**DEFENSE NUCLEAR FACILITIES  
SAFETY BOARD**

### **Safety Posture of the Principal Underground Laboratory for Subcritical Experimentation and Associated Major Modification Projects**

**SUBJECT:** NNSS PULSE ECSE PDSAs and Seismic Faults

**Figure 1.** Fault distribution within PULSE [10]. Solid red lines indicate observed faults and dashed red lines indicate inferred faults.

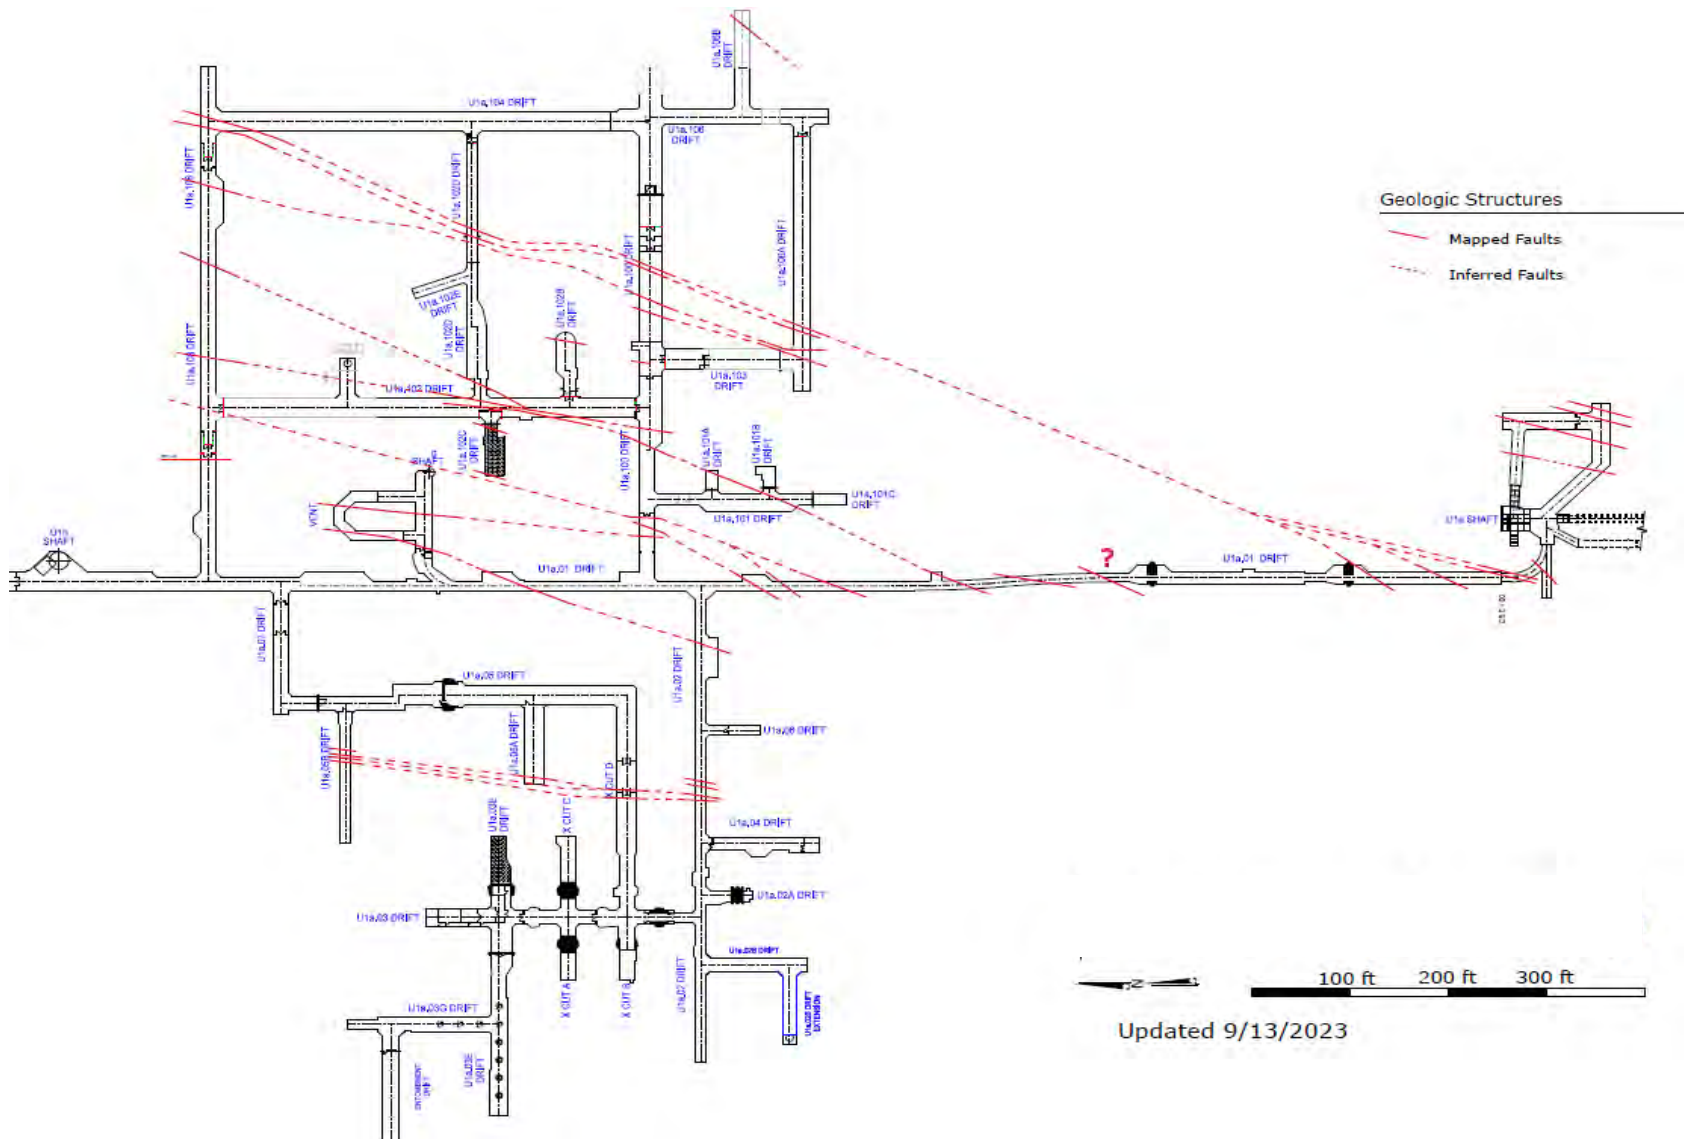
*Uncharacterized Seismic Faults in PULSE*—Seismic faults are extensively exposed within the PULSE tunnels with more than 50 individual locations based on the fault distribution map (Figure 1). Although these faults are dispersed across various tunnel sections and not directly interconnected, they are part of the fault system, as some can be linked to form longer faults based on their orientations and fault types. NNSS geologists currently consider the faults present in PULSE to have occurred in the Tertiary period<sup>4</sup> instead of the Quaternary period. Evidence from NNSS geological reports [6–9], along with observations during the staff team’s walkdowns, indicate that the faults within the PULSE tunnels could be younger and potentially be Quaternary.

Faults within PULSE, if active, can trigger earthquake vibrations that could potentially initiate the high explosive within the subcritical experiment package. Both ECSE subprojects credit several controls for seismic accident scenarios, such as the Zero Room structure, anchoring for overhead equipment in the Zero Room, and the fire extinguishing system. Seismic design requirements for these controls rely on an earthquake database managed by USGS which does not currently account for the faults within PULSE. Accordingly, the seismic hazard may exceed design requirements, and these safety controls may not be able to perform their intended safety function during or after a seismic event.

**Figure 2.** *Potential impact of faults within PULSE, displacing drifts and triggering earthquake vibrations.*

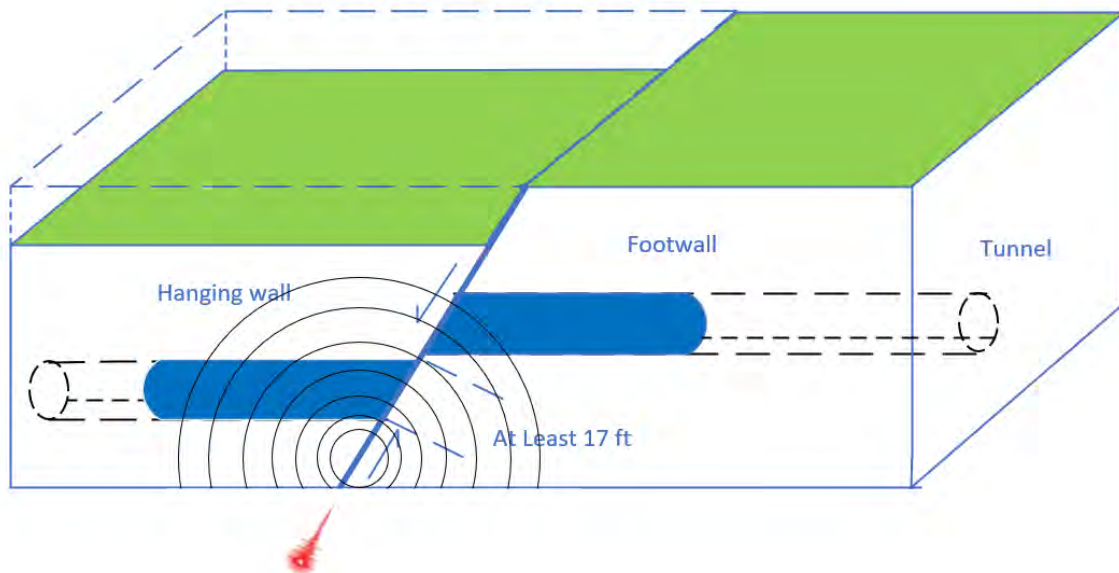
The safety design basis documents for the ECSE projects do not analyze a fault displacement hazard scenario. NNSS personnel consider this scenario to be bounded by the analyzed scenario in which a seismic event results in overhead equipment falling onto a subcritical experiment package [2]. The safety design basis documents credit the shipping container to protect the subcritical experiment. The magnitude of a fault displacement is typically proportional to the dimension of the faults [11]. Given that the dimensions of the faults in PULSE are uncharacterized, the potential magnitude of the fault displacement event is unknown but could potentially be 17 feet or greater (Figure 2). The shipping container may not be able to fully protect the subcritical experiment from a severe displacement. As a result, the ECSE safety basis documentation should analyze this event separately as a unique hazard.

Because the PULSE faults are not included in the USGS database, all NNSS facilities (e.g., DAF) may be underestimating the seismic hazard. Also, important NNSS infrastructure, such as highways and electrical transmission lines, could be potentially severed due to fault displacement.

**Figure A-1.** Fault distribution within PULSE [10]. Solid red lines indicate observed faults and dashed red lines indicate inferred faults.

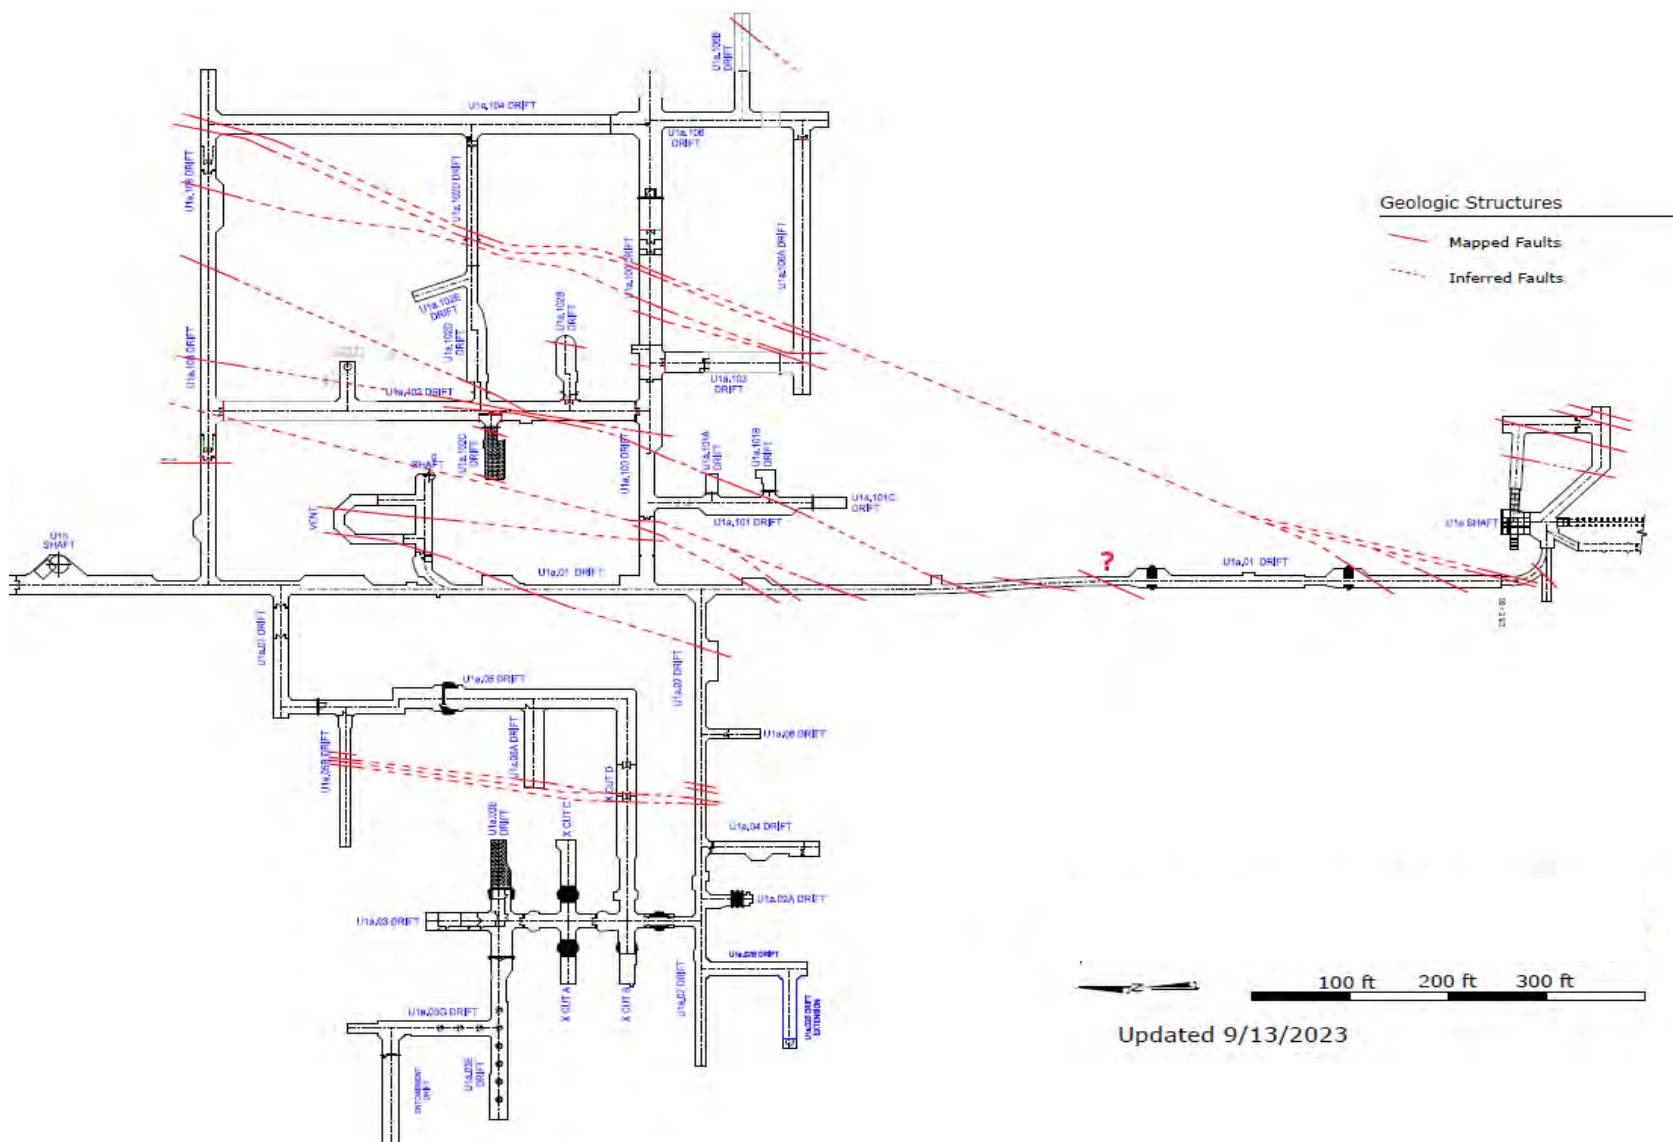
**Extensive Presence of Seismic Faults within PULSE.** Seismic faults are extensively exposed within the tunnels with more than 50 individual locations based on the fault distribution map (Figure A-1). These faults are primarily normal faults. In this type of fault, the block above the fault line moves downward relative to the block below (Figure A-2). The faults observed in the U1a.01 drift predominantly strike in a north-south or northeast direction with a dipping angle of approximately 80 degrees, consistent with the descriptions in NNSS geological reports.

Although these faults are dispersed across various tunnel sections and not directly interconnected, they are part of the fault system, as some can be linked to form longer faults based on their orientations and fault types. The longest ones can potentially extend more than 1,000 feet (Figure A-1). These faults also have displacements of more than 17 feet, which exceeds the height of the tunnels in the drifts east of the U1a.01 drift [6]. Fault displacements west of the U1a.01 drift are relatively smaller, less than the height of drifts. Polished surfaces (termed “slickensides”) and rocks formed by grinding (termed fault gouges) due to movement along both sides of faults are common, indicating previous earthquake activity (Figure A-3). The staff team’s walkdowns within the tunnels affirmed the descriptions including the fault orientations and attitudes provided in the NNSS reports [6–9].

**Figure A-4.** *Potential impact of faults within PULSE, displacing drifts and triggering earthquake vibrations.*

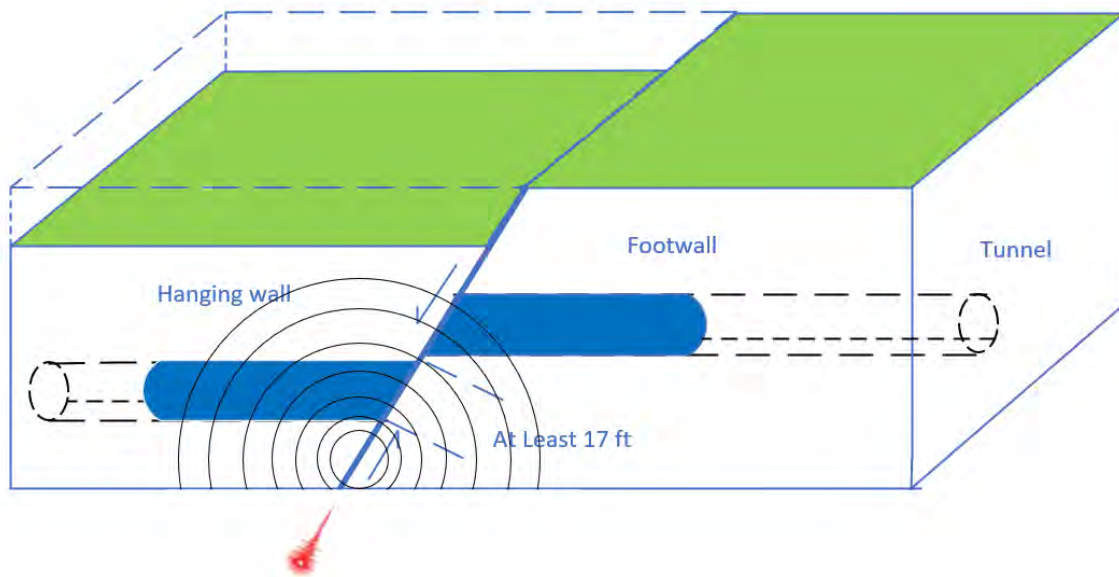
The magnitude of the fault displacement is typically proportional to the dimension of the faults [11]. Given that NNSS personnel have not characterized the dimensions of the faults in PULSE (e.g., the faults could extend to the north or south for many miles), the potential magnitude of the fault displacement event is unknown. Additionally, normal faulting events could displace the underlying layers, which could consist of various hard rocks. If a more severe displacement were to occur, then the shipping container may not be able to fully protect the

subcritical experiment (Figure A-4). As a result, the ECSE safety basis documentation should analyze this event separately as a unique hazard.
